Appendix 13.3

LVIA METHODOLOGY

Bailey Johnson Hayes Ltd. was commissioned by Albion Land Ltd in July 2021 to prepare a Flood Risk Assessment (FRA) and Drainage Assessment to support an Outline Planning Application for the proposed development at Junction 10 of the M40, Baynard's Green, Bicester. The Development has 2 parcels of land and there will be 2 Planning Applications for the Eastern and Western sides of the A43. The Flood Risk Assessment has been prepared in accordance with the guidelines set out in the National Planning Policy Framework and regional/ local policy and guidance.

SCOPED OUT PHOTOVIEWPOINTS

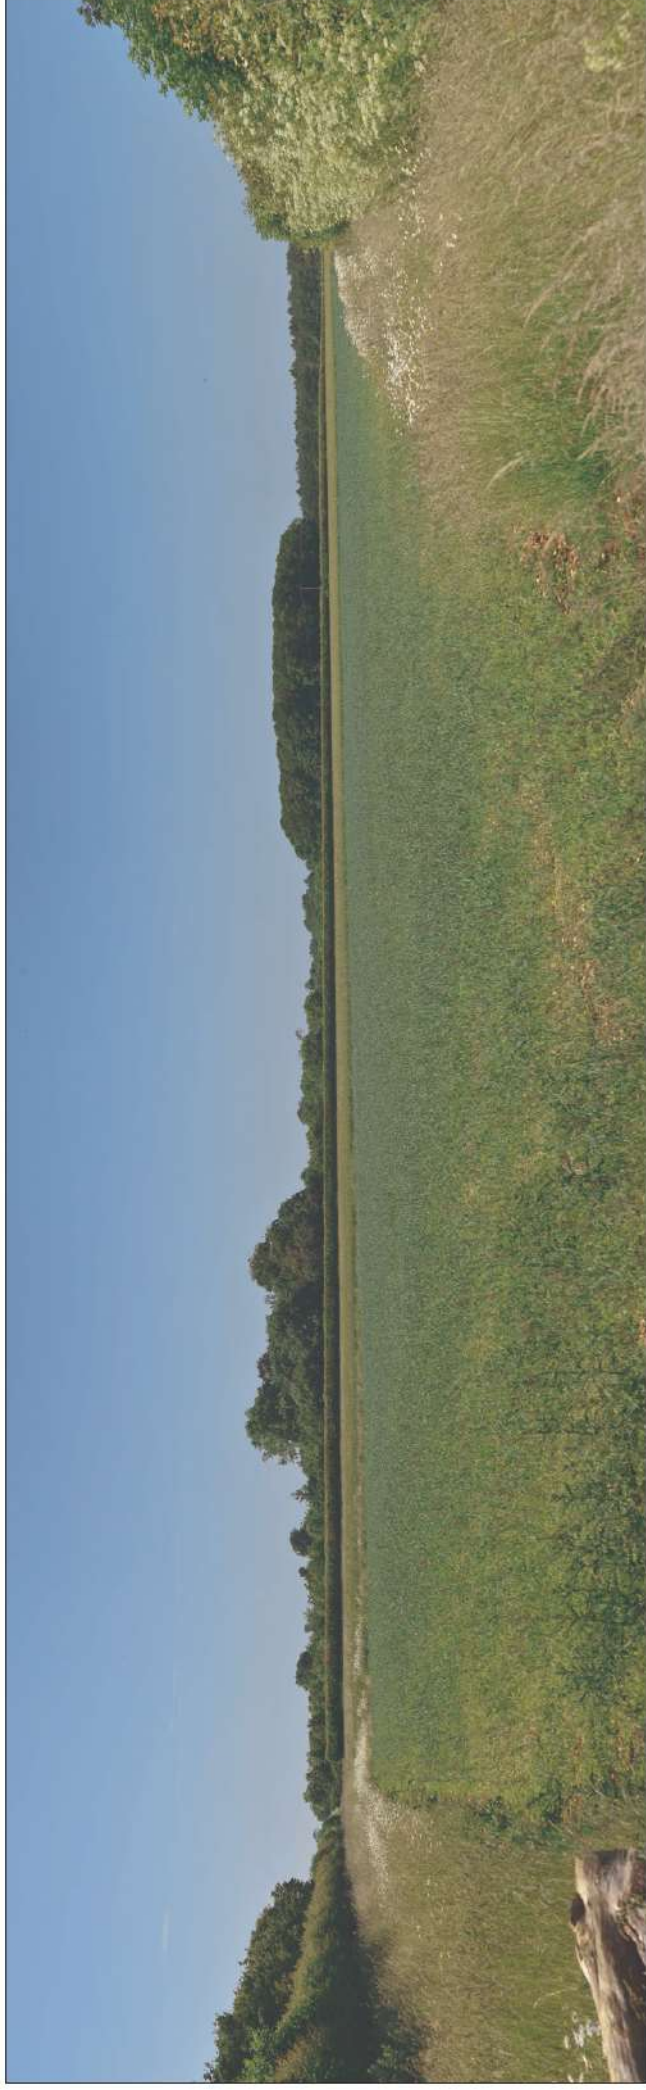
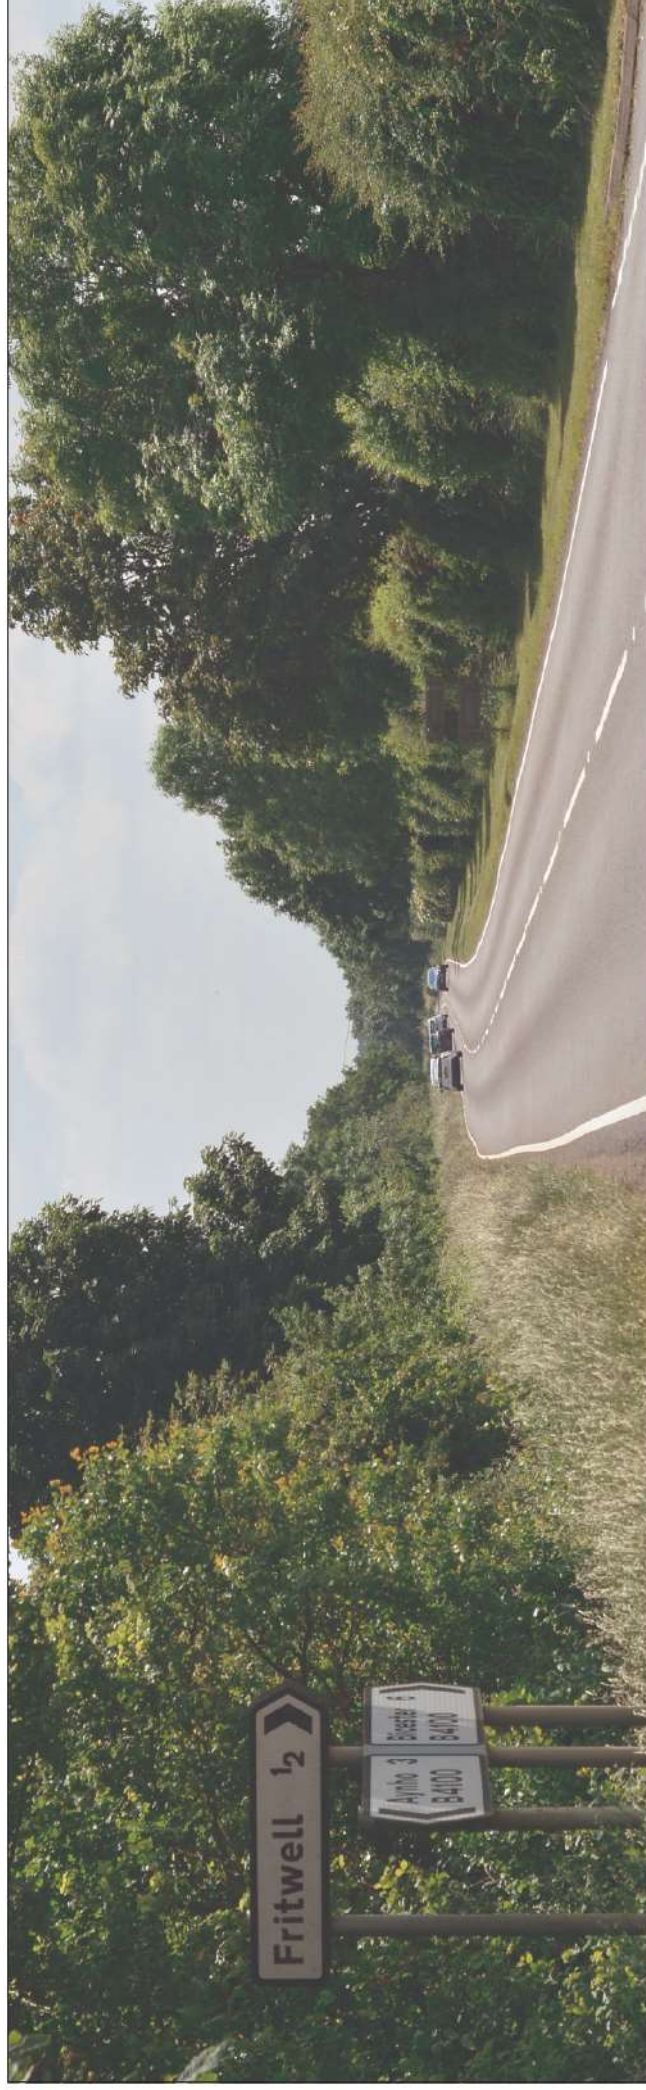
The 'scoped out' viewpoints do not have to be photographically recorded, however I would prefer to see a narrative for each as they are in 'logical' locations on the plan (if intervening topography obscures the site/scale/massing then this should be mentioned). I would like to see a photo-record for A because this is a visual receptor on/near an important heritage receptor.

The rest of the viewpoints are a good representation of the visual experience. I personally would include a two view (or more) sequence of the PRow approach to the site, where the receptor may have an enhanced experience of the site's scale/massing, which would directly influence weighting and subsequently the design of the landscape masterplan.
